ALTERATION TO A HISTORIC PROPERTY STAFF REPORT

Site: 27 Columbus Avenue c.1892 Julia Gustin
Case: HPC 2016.078 Single Building Local Historic District

Legal Notice: *Replace one 70's-era casement window in 2nd floor street-facing side and one 70's era sliding glass window on 3rd floor with one-over-one double hung windows.*

Windows to be altered and replaced.

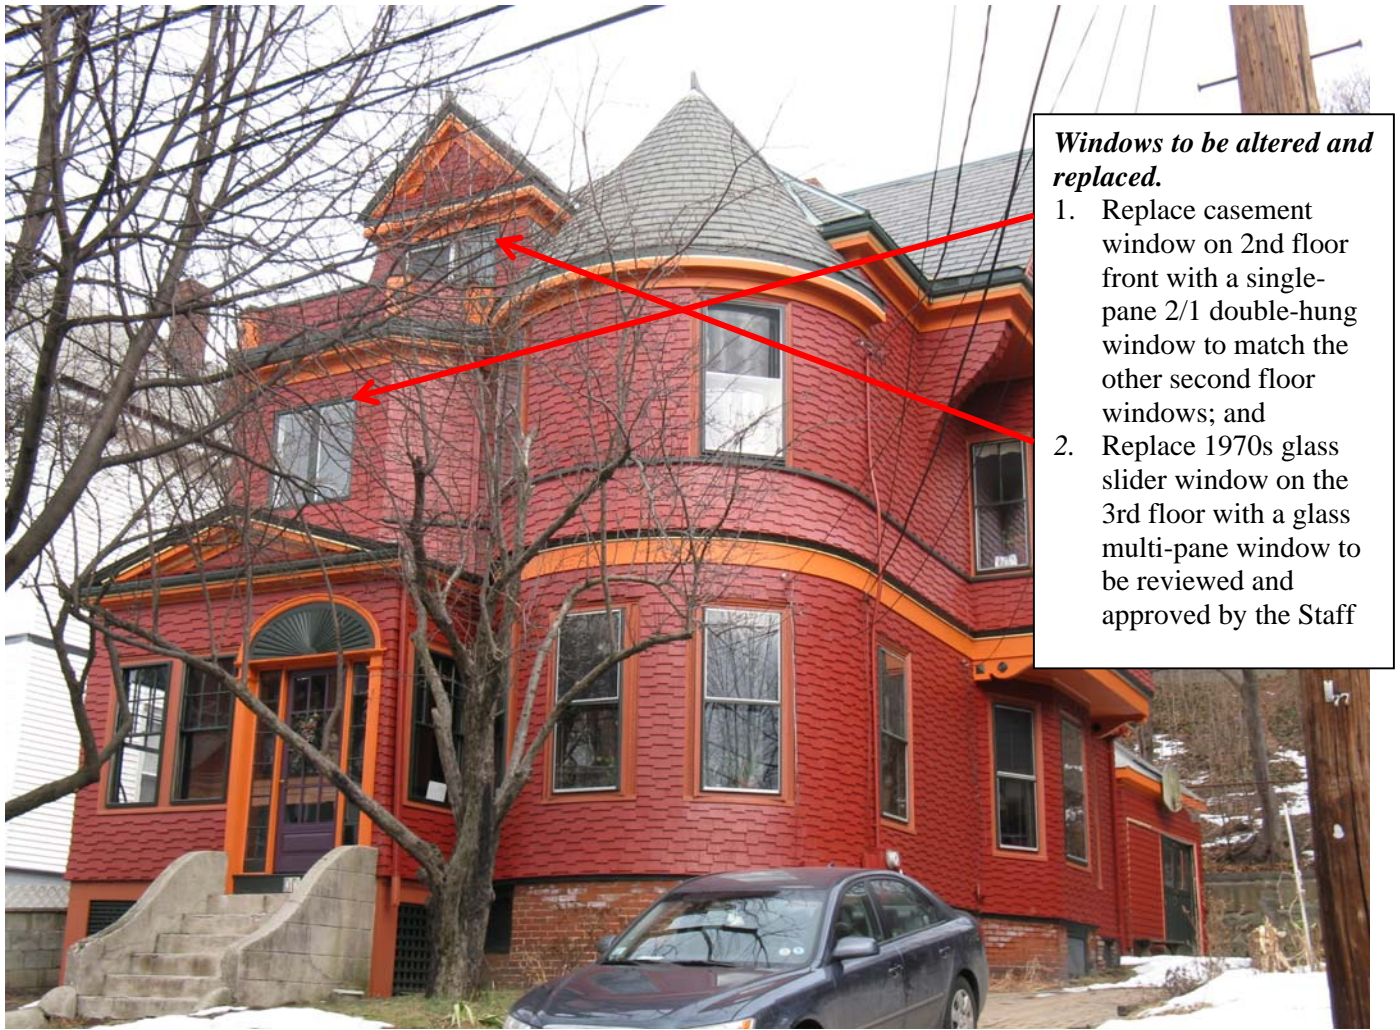
The windows were not discussed in the Form B. The deteriorated windows are not original to the building and should be replaced with a more historically appropriate configuration. No historic features will be replaced or altered. The original window styles are not known although it is likely that the sash had a 2/1 or 1/1 configuration. The windows are visible from the public right of way.

There is no intent to alter the openings. Interior photos show the bull's eye corner blocks and railroad casing to be different on each window. The second floor casing appears to be a replacement while the third floor casing appears to be original. This is a case where one original opening is unknown. If the sizing is correct, it is likely that it was a Queen Anne window. This would have had small colored panes surrounding a large clear glass pane. If the opening was made smaller to hold the existing sash, it is likely that the window was double-hung and rose to the stringcourse on the second floor similar to the other windows on that floor. The third floor window may have been a decorative Queen Anne window that fit the existing casing.

1. Replace casement window on 2nd floor front with a single-pane 2/1 double-hung window to match the other second floor windows; and
2. Replace 1970s glass slider window on the 3rd floor with a glass multi-pane window to be reviewed and approved by the Staff
